MANDATORY SERVICE BULLETIN NO. MSB 62-028 REV. 1
SUPERSEDES MSB 62-028 REV. 0

Type: DA 62

Replacement of baggage nets with defective buckles.

Figure 1 - DA 62 baggage net installation.

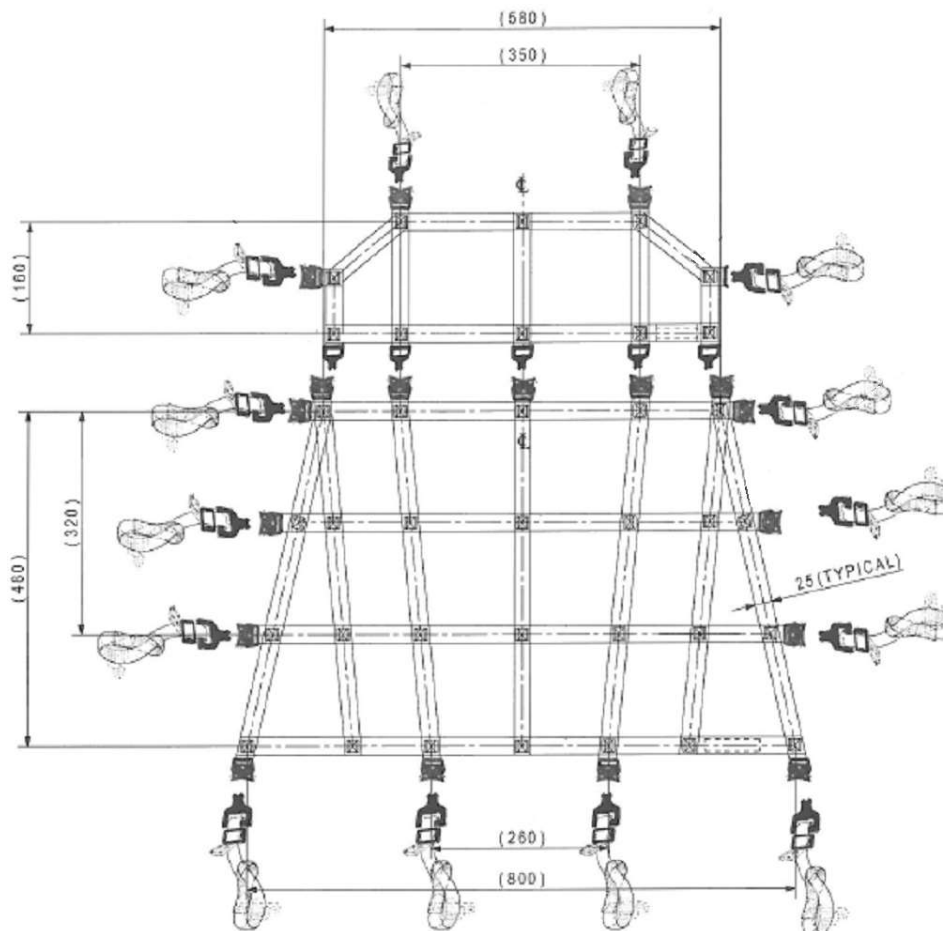
It has come to Diamond's attention that baggage nets with defective buckles have been installed on several aircraft due to a quality escape. These defective buckles may not maintain sufficient holding force and could pose a hazard to the passengers and crew. Effective immediately, these cargo nets are not to be used. Diamond will provide replacement nets to all those affected.

1. Refer to Section I.2. Identify if the baggage net in the aircraft is an affected net. Use the part number and the date of manufacture to identify the net.
2. If an affected net is installed, clearly mark the currently installed net as defective, and remove it from the aircraft.

3. Install the new "Quick Fix Baggage Net Assy" (P/N D67-2550-90-00_02) provided by Diamond Aircraft Industries.
4. Destroy the removed baggage net assembly, or return it to Diamond Aircraft Industries.
